Service Bulletin

Bulletin No.: PI0973

Subject: Rub Type Noise Heard with Steering at Full Turn (Steering Stop) While Driving
(Vehicles Equipped with Optional Dealer Installed 19" Wheels Only)

Models: 2013 Cadillac ATS with Dealer Installed 19" Wheel/Tire Package
Condition/Concern

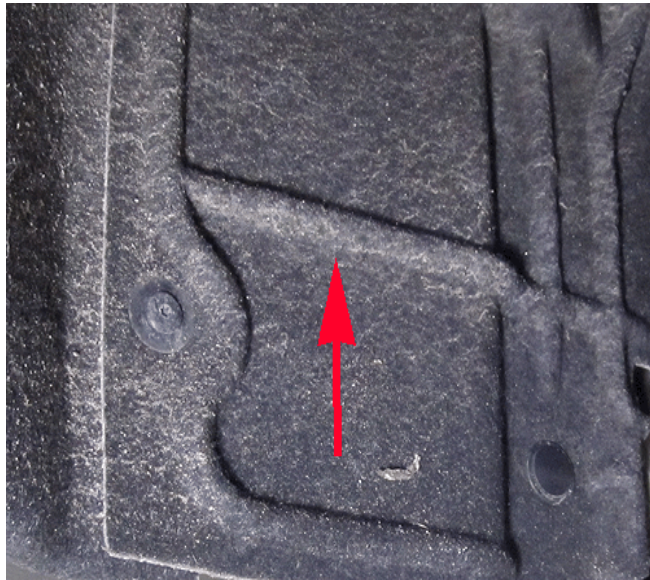
Some customers may comment that after the installation of the 19" accessory wheel and tire package, there is a rubbing noise heard at full turn (steering stop) while driving.

This condition may be caused by the tire contacting a raised section of the front wheelhouse splash shield.

Use the following steps to determine if the updated splash shield is installed on the vehicle and to heat and reshape the splash shield to allow for clearance.

1. Determine if the vehicle is equipped with the updated design wheelhouse shield.

3383092

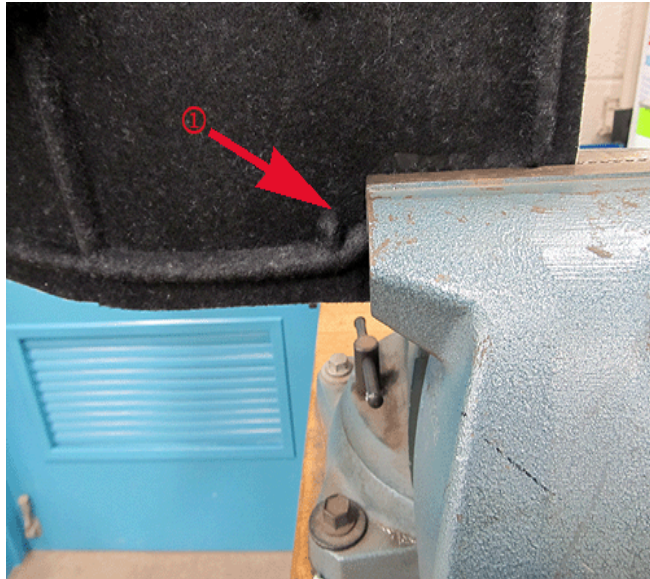
3. Heat the wheelhouse splash shield in a localized area to soften the part for approximately 1 minute (holding 1-2 inches above the part).

3383096

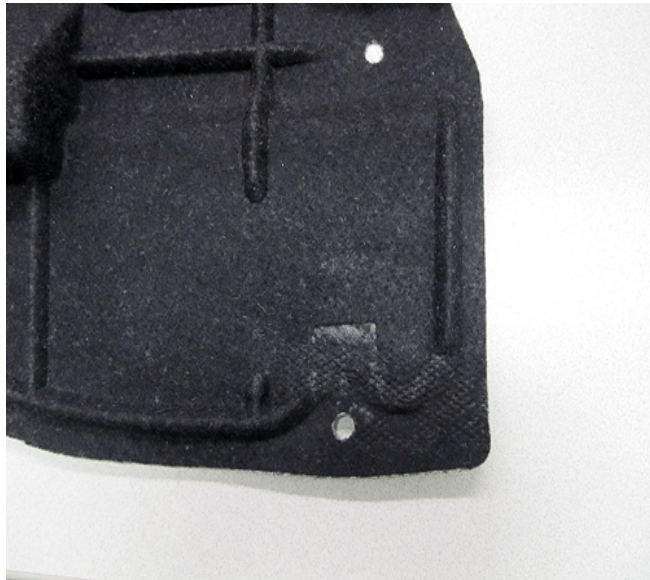
4. Using a bench vise, insert the splash shield as shown and close the jaws on the vise.
Do not go past the rib (1) when inserting the splash shield into the vise. Allow the part to cool in the vise for a few minutes.

Ensure the ridge is flattened as shown. If not, repeat the above steps.
